ADDENDUM NUMBER 001

Date: April 6, 2026
EDR Project No.: **21004**

COPA LIFEGUARD HEADQUARTERS
303 Ninth Street
Port Aransas, Texas 78373

Addendum 1-1
EDR Project No. 21004
04/06/2026

REGISTERED PROFESSIONAL ENGINEER
STATE OF TEXAS
ROBERT ENRIQUEZ MARTINEZ
89387
MECHANICAL
EXPIRATION DATE 08/25/2020

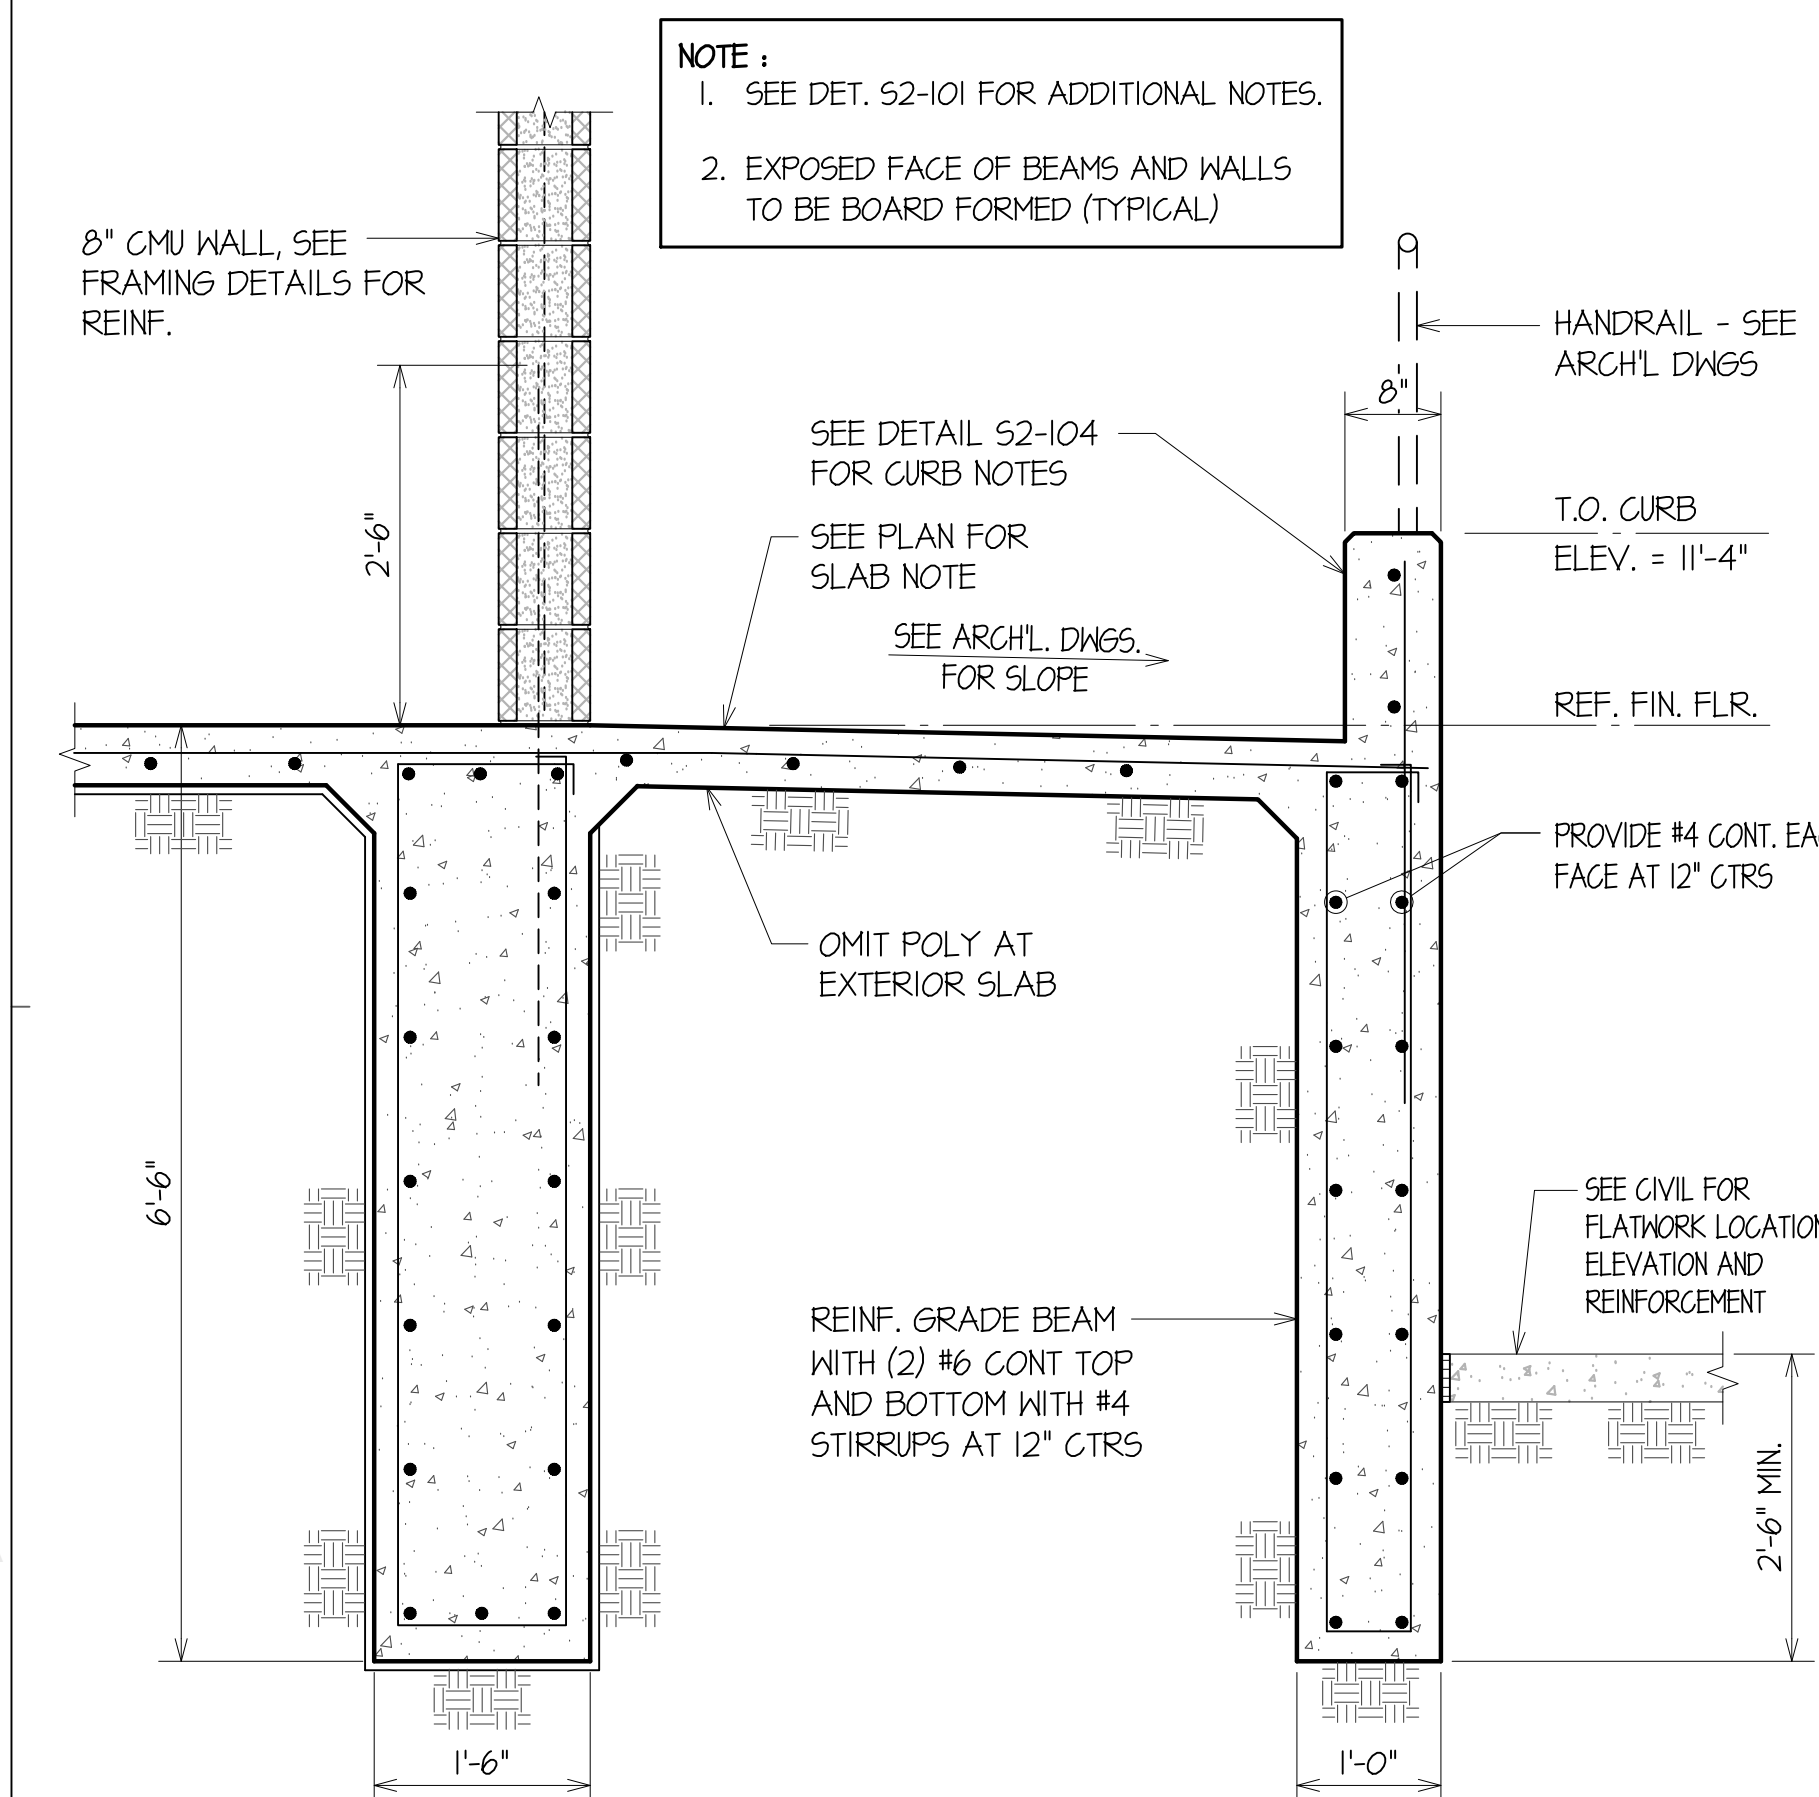
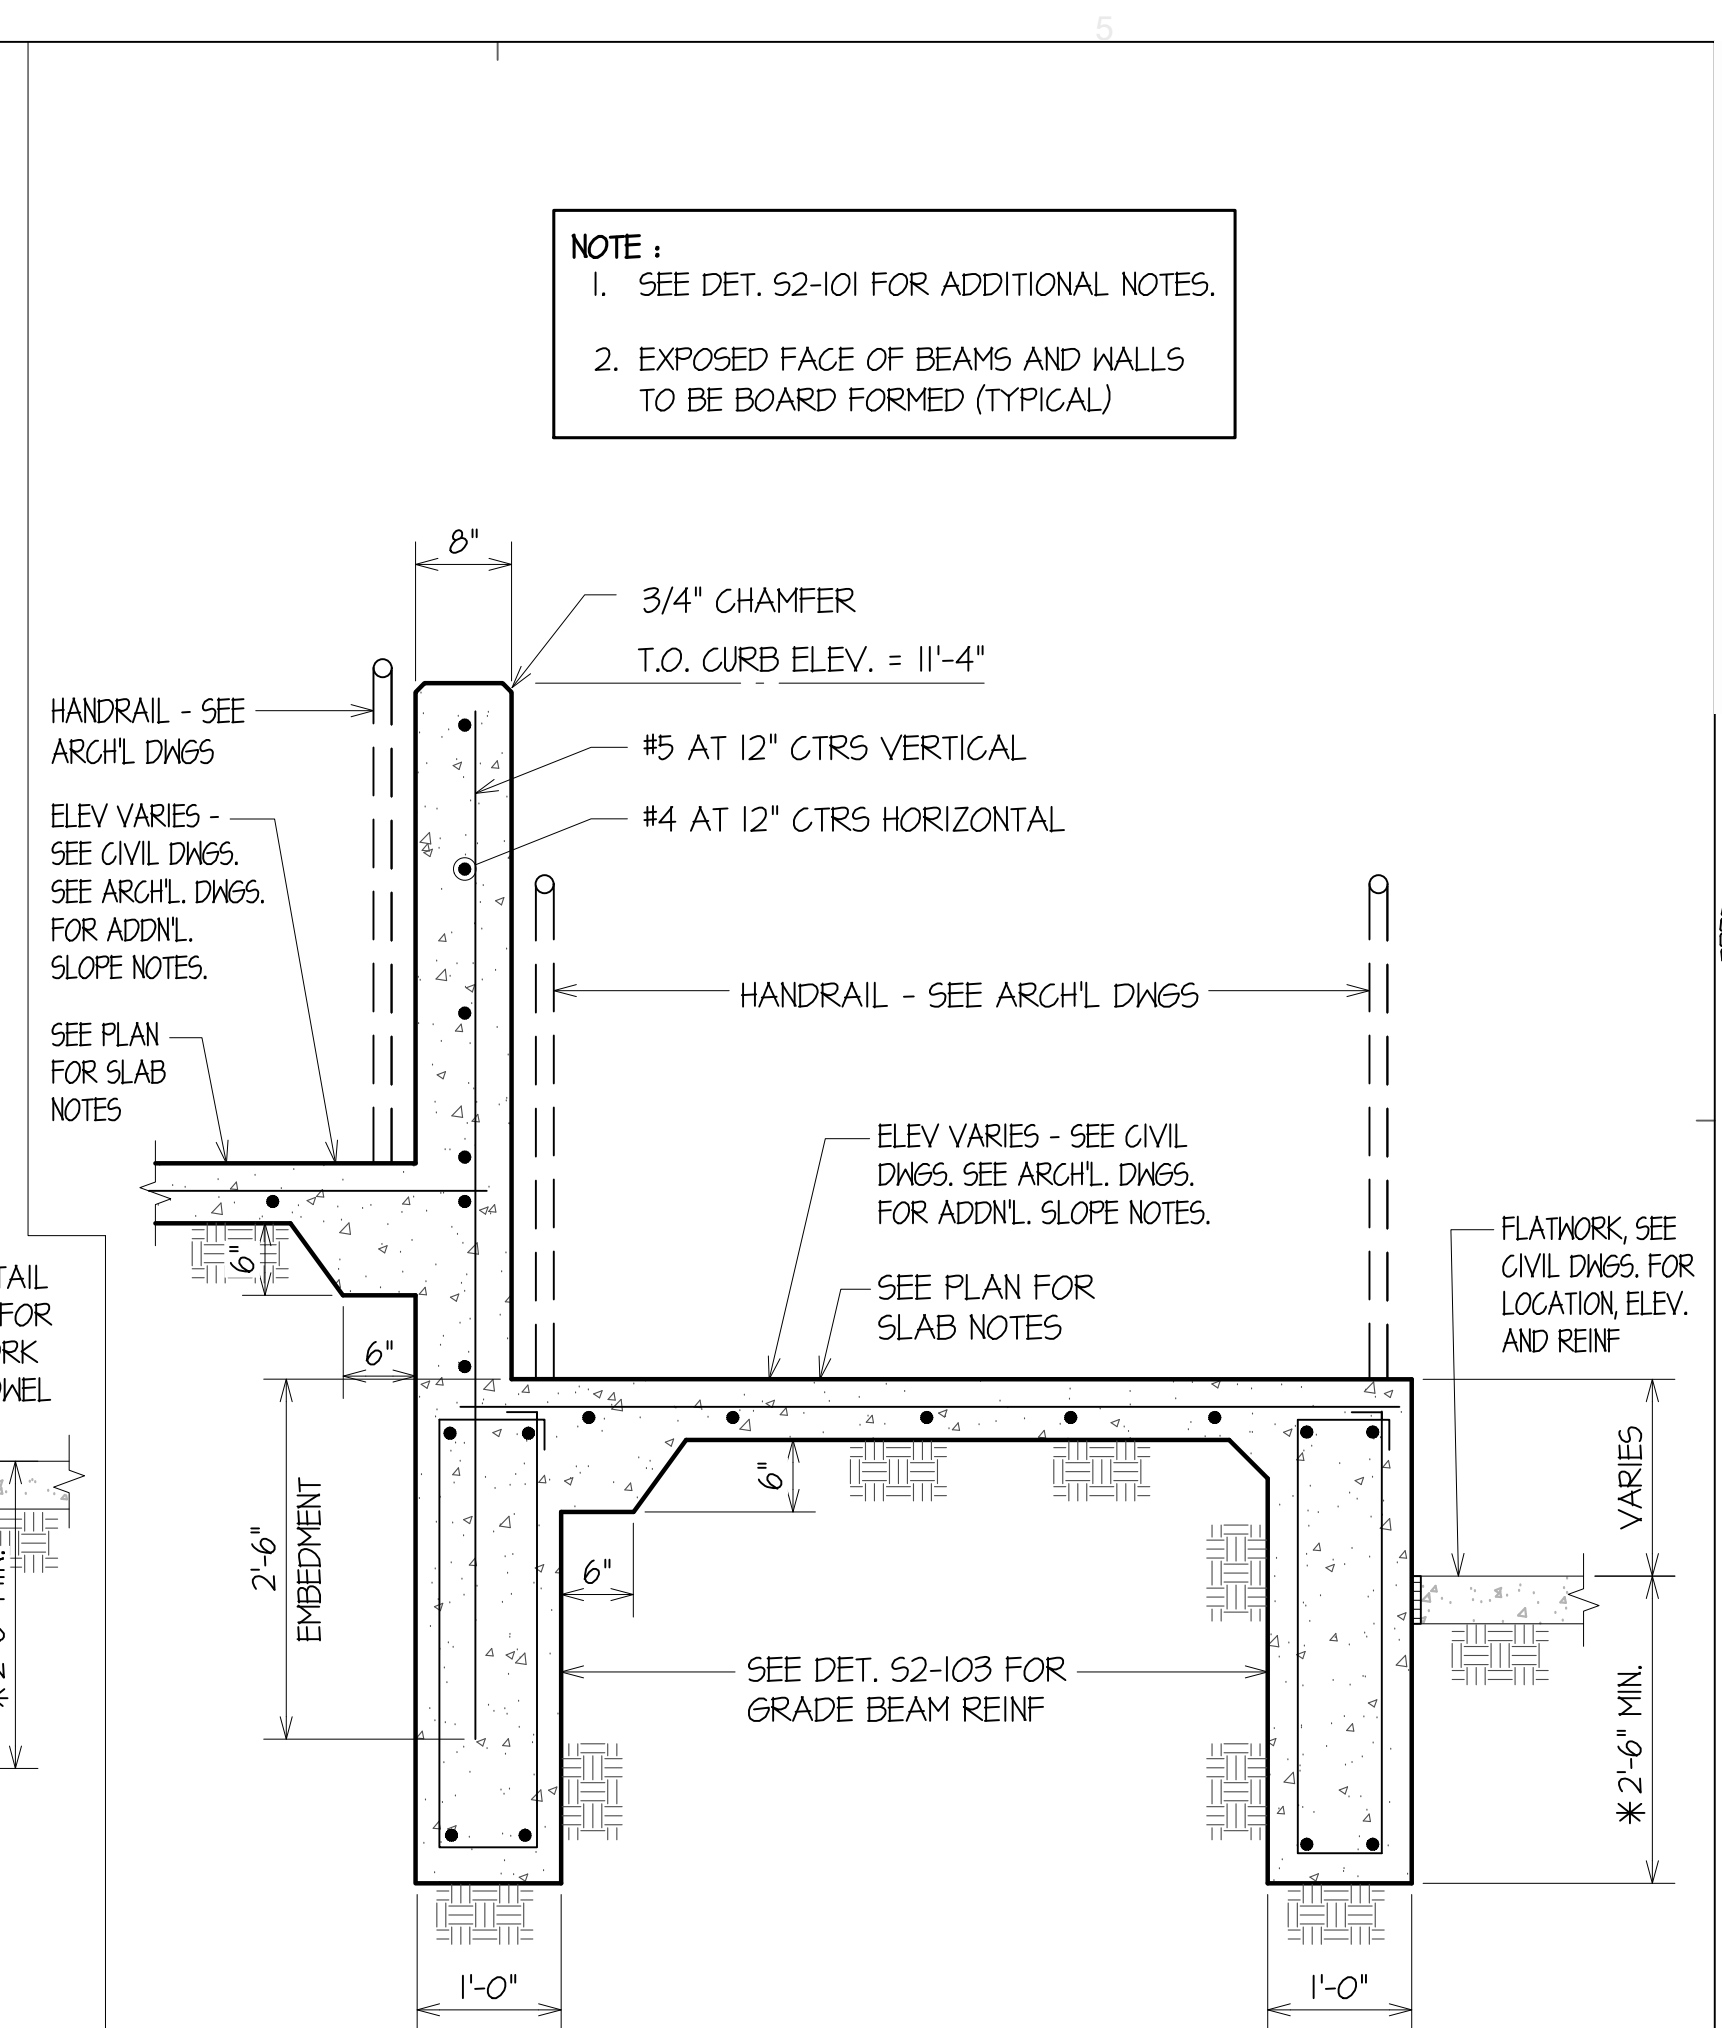
Sheet S1-1 – Foundation Plan and Roof Framing Plan

- a.) Hanger channel and details added at change in roof elevation along Grid 4.
- b.) Uplift and wall pressure diagram added to plan.
